City of Crystal Lake

# Memorandum

**Date:** June 14, 2013

**Re**: 2013-22 Goodwill

1 **Exterior Elevations - West View**
Scale: 3/32" = 1'-0"

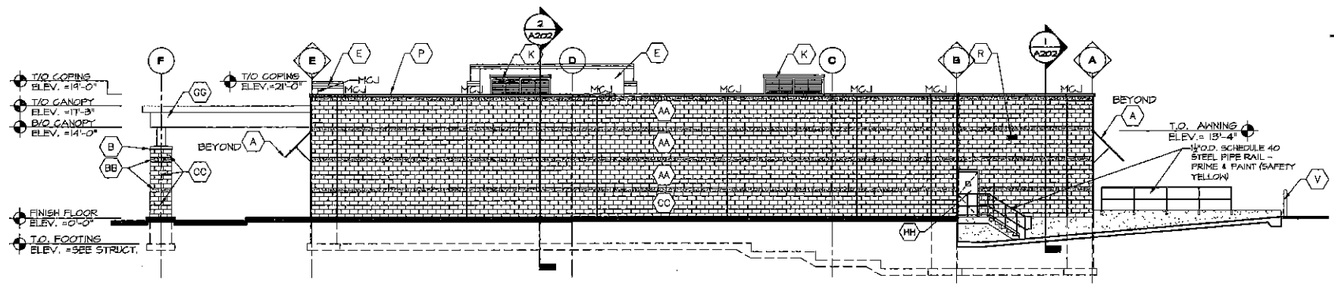
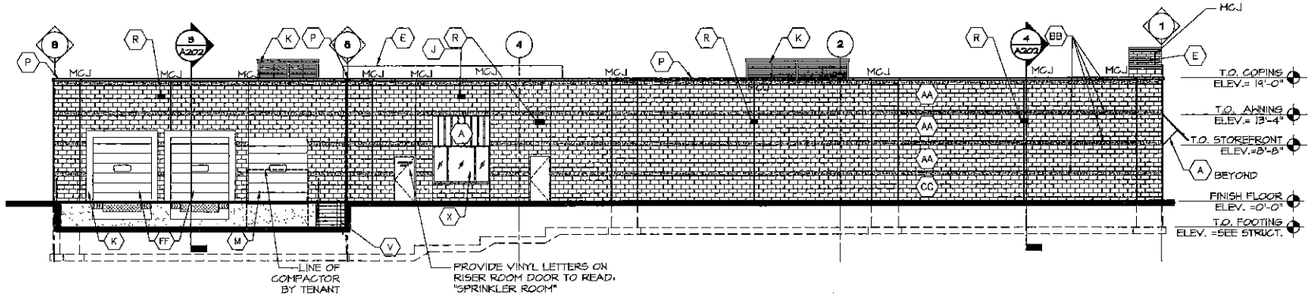
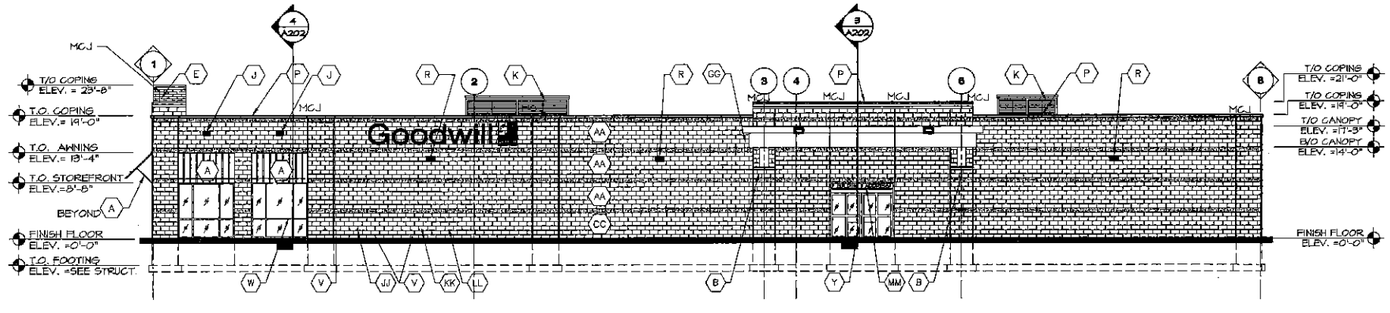
- The building is primarily constructed of CMU block. The main building will be split face CMU Oak color. The bottom level of block will be split face colored Cedar. Three layers of banding are proposed, which will be smooth face CMU colored Oak.
- There are two parapet roof projections proposed. The first is over the main customer entrance. This extends about 4 ½ feet above the main plane of the roof. This entry section will be constructed with concrete brick veneer colored Oak. The second is above the customer donation area. This only extends 2 feet above the main roof plane.
- The roof-top mechanical equipment will be screened.
- All of the windows and the main customer door have awnings above them. The awnings will be Goodwill's blue color.
- The windows along the west elevation go to the ground and do not have a knee wall.

- ◊ Building Massing and Articulation. These criteria are not met. The building does not provide any structural articulation or any 2-foot projections or recesses.

- ◊ Overall Façade. These criteria are not met. The building does not have a clear base, middle and top and there is no articulation of the façade planes. Also the drive-through is not architecturally integrated into the building façade.

3. Elevations
   A. To meet the UDO Design Standards the building shall have:
      1. The roof design shall match the other buildings on the site and have peaked roofs over the main entrance and the donation canopy. These entries shall project a minimum of 2 feet from the main wall plane.

2. A thicker top stone cap shall be added along the parapet roof line.
      3. The faux columns shall be real columns that project at least 2 feet along the street side elevations and incorporate the design elements in the Wal Mart and Central Park Retail columns.

B. If the above comment A cannot be addressed, then at the very least, the entry way shall be projected a minimum of 2 feet, the faux columns shall be real columns that project at least 2 feet and the windows shall have a knee wall.
